EQUIPEMENTS CONCERNED

Advance Tandem system T1 and T2

ALL Advance Tandem T1 and T2 MFG

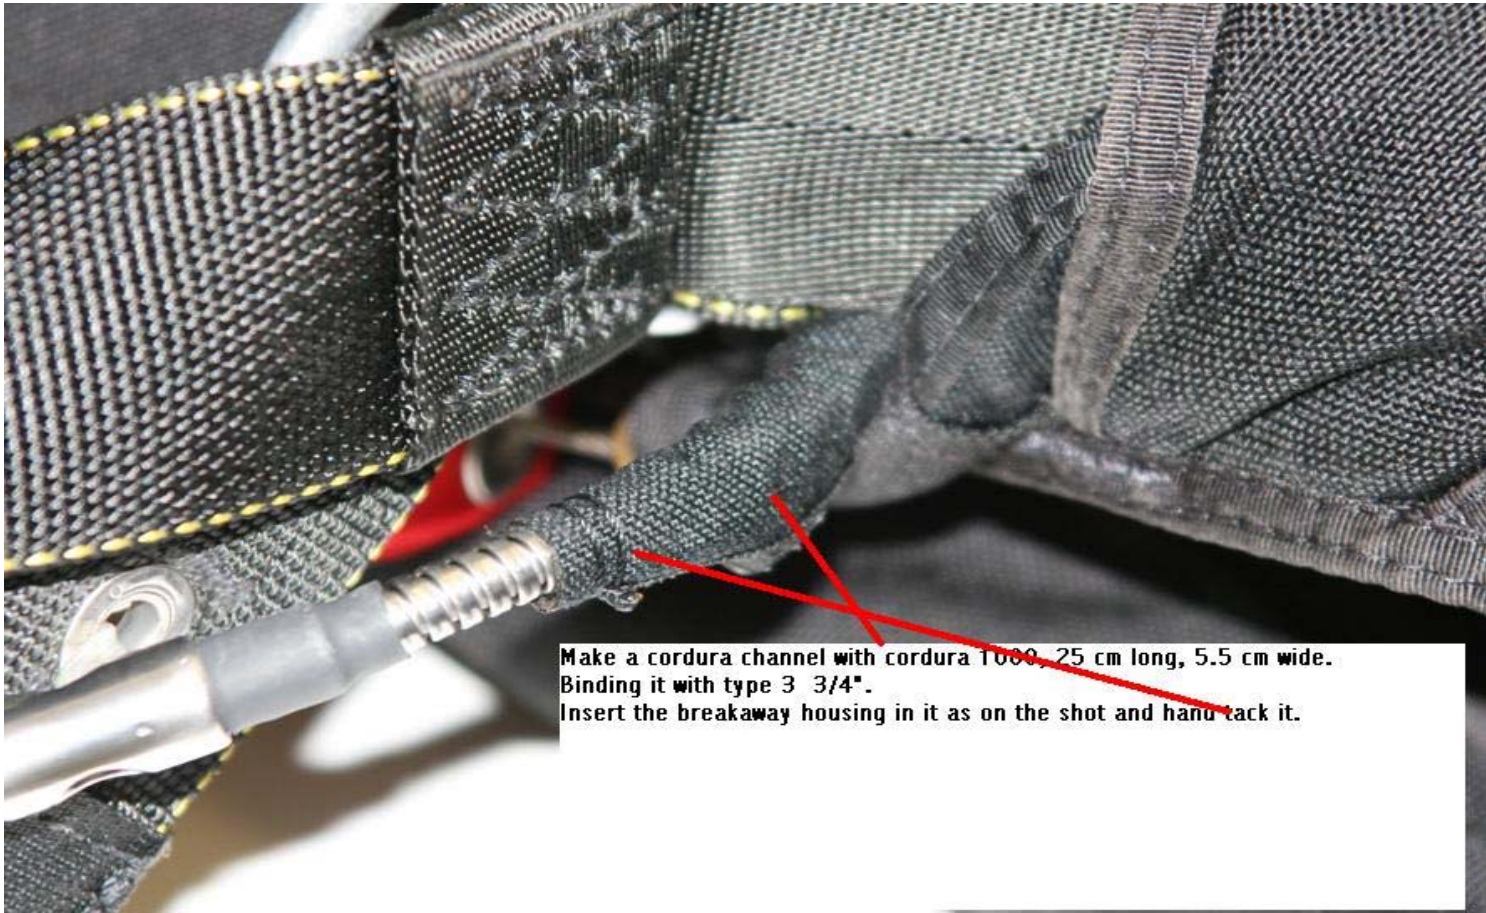
It is requested to all Advance tandem user to verify the left side diagonal back strap at the reserve housing level. The reserve housing is located on the shoulder right upper the 3 ring system. This check is focus to the potential wear out of this webbing by the Oeticker clamp (as explained in the SB AV070718) but by the friction of the breakaway and the reserve housing either.

Potential risk of damage on the type 8 webbing because of the clamp and both housings frictions on the webbing. The damage runs until the housing cannot touch the webbing anymore. This damage is up to one inch deep (page 2).

During opening tension the reserve housing (all Tandem models) and breakaway housing (MFG date before 04/2006) can be in contact with the type 8 left side diagonal backstrap. These frictions potentially damage the webbing.

- ° Before any jump, the webbing wear out must be checked
- ° Both housings must be protected as described pages 2 and 3
- ° If the damage is over 2 cm wide the H/C must be grounded and repaired
- ° If the damage is less than 2 cm the repair will have to be made at the next reserve packing cycle.

Protecting sleeves can be ordered through Basik Air Concept at no charge and will have to be installed as described page 2.
If a damaged webbing is found you must get in touch with us at basik.fr@free.fr
A certified Master Rigger can make the repair after getting our repair plan.
If the Oeticker clamp is installed the wrong way the clamp must be uncrimped, turn back inside the tape and reset.
If you cannot reset it, a hand tacking can be made to maintain the housing.
This must be done by a certified Master Rigger

Make a cordura channel with cordura 1000, 25 cm long, 5.5 cm wide.
Binding it with type 3 3/4".
Insert the breakaway housing in it as on the shot and hand tack it.
